Form 3160-5 (June 2019)	UNITED STATES DEPARTMENT OF THE INTERIOR BUREAU OF LAND MANAGEMENT	FORM APPROVED OMB No. 1004-0137 Expires: October 31, 2021
SUNDRY NOTICES AND REPORTS ON WELLS <i>Do not use this form for proposals to drill or to re-enter an abandoned well. Use Form 3160-3 (APD) for such proposals.</i>		5. Lease Serial No. NMNM078968A
		6. If Indian, Allottee or Tribe Name

EOG respectfully requests an amendment to our approved APD for this well to reflect the following changes:

Pretty Good 20 Fed Com 707H API #: 30-025-51794

Revised Permit Information 04/17/2024:

WELL LOCATION AND ACREAGE DEDICATION PLAT

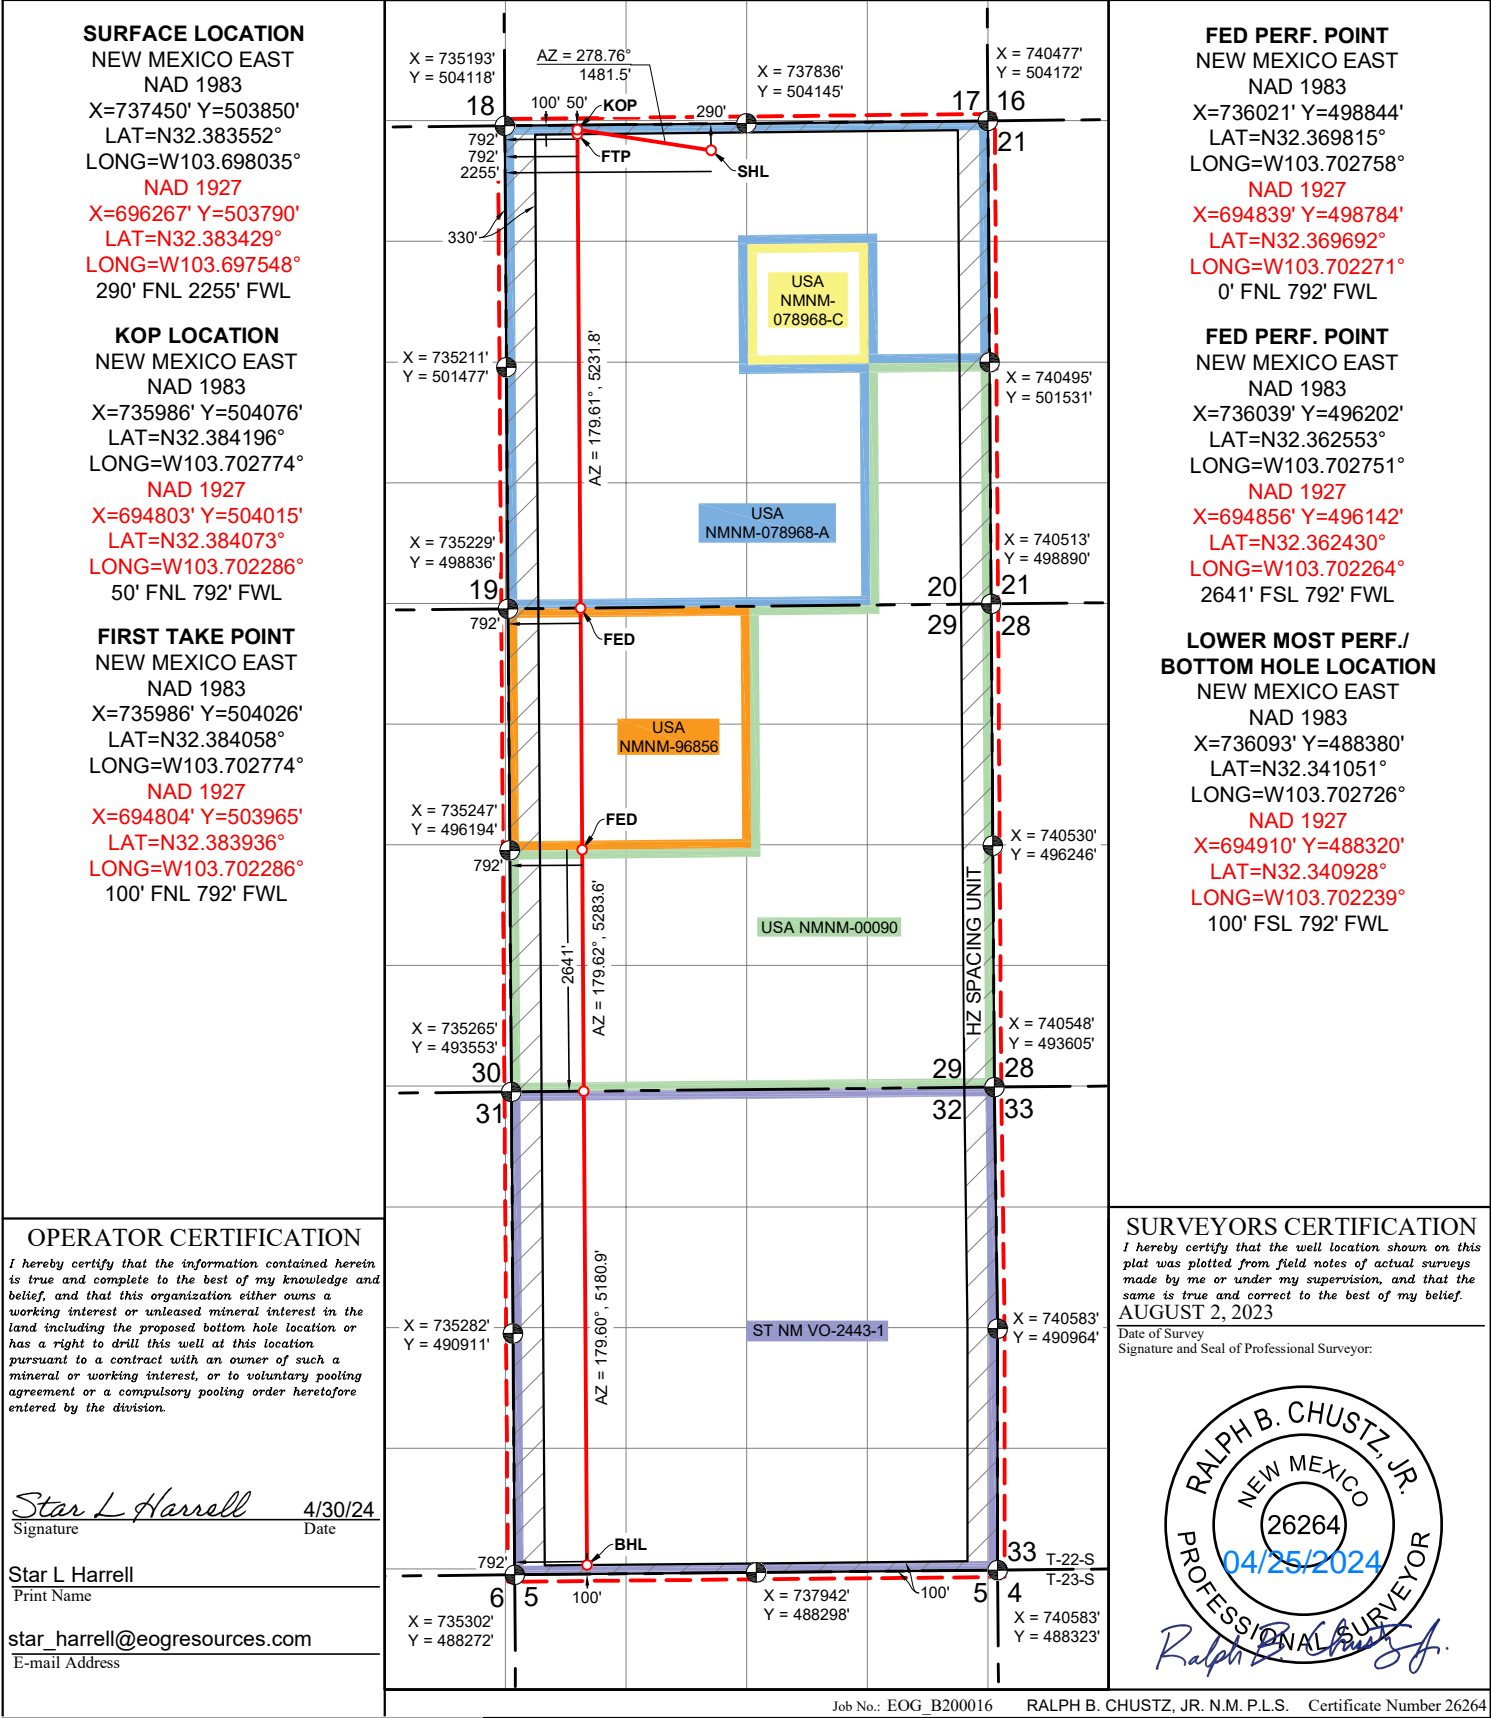
Change BHL from T-22-S, R-32-E, Sec 32, 100' FSL, 1830' FWL, LEA Co., NM,
to T-22-S, R-32-E, Sec 32, 100' FSL, 792' FWL, LEA Co., N.M.

Update HSU to 1920 acres.

UL or lot no.	Section	Township	Range	Lot Idn	Feet from the	North/South line	Feet from the	East/West line	County
M	32	22 S	32 E		100	SOUTH	792	WEST	LEA

Dedicated Acres 1920	Joint or Infill	Consolidated Code	Order No. PENDING COM AGREEMENT AND NSP
-------------------------	-----------------	-------------------	--------------------------------------------

Revised Wellbore

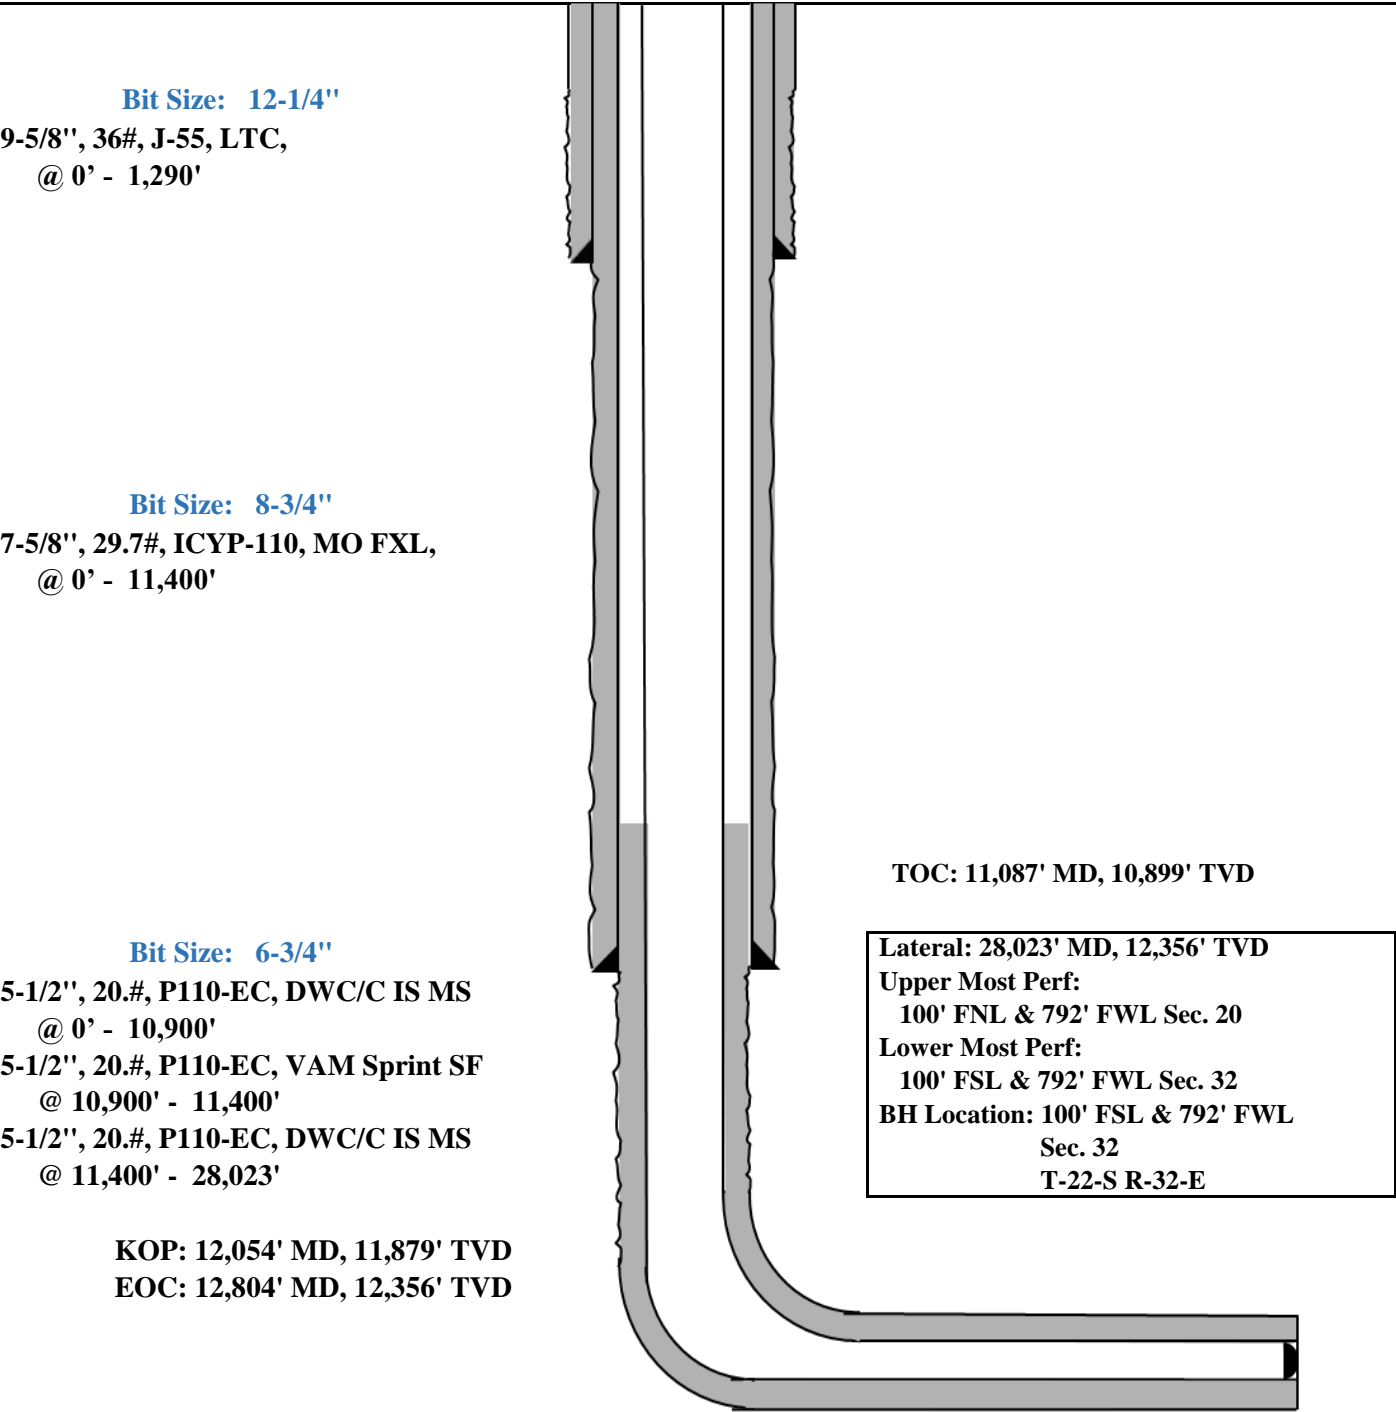
Update casing and cement program to current design.

Allow for full string of either 5.5" 20# P110-EC DWC/C IS MS or 6" 22.3# DWC/C IS depending on availability of casing.

Hole Size	Interval MD		Interval TVD		Csg OD	Weight	Grade	Conn
	From (ft)	To (ft)	From (ft)	To (ft)				
12-1/4"	0	1,290	0	1,290	9-5/8"	36#	J-55	LTC
8-3/4"	0	11,587	0	11,400	7-5/8"	29.7#	ICYP-110	MO FXL
6-3/4"	0	11,087	0	10,900	5-1/2"	20#	P110-EC	DWC/C IS MS
6-3/4"	11,087	11,587	10,900	11,400	5-1/2"	20#	P110-EC	VAM Sprint SF
6-3/4"	11,587	28,023	11,400	12,356	5-1/2"	20#	P110-EC	DWC/C IS MS

Variance is requested to waive the centralizer requirements for the 7-5/8" casing in the 8-3/4" hole size. An expansion additive will be utilized, in the cement slurry, for the entire length of the 8-3/4" hole interval to maximize cement bond and zonal isolation.

Variance is also requested to waive any centralizer requirements for the 5-1/2" casing in the 6-3/4" hole size. An expansion additive will be utilized, in the cement slurry, for the entire length of the 6-3/4" hole interval to maximize cement bond and zonal isolation.

Variance is also requested to waive the annular clearance requirements for the 5-1/2" casing by 7-5/8" casing annulus to the proposed top of cement.
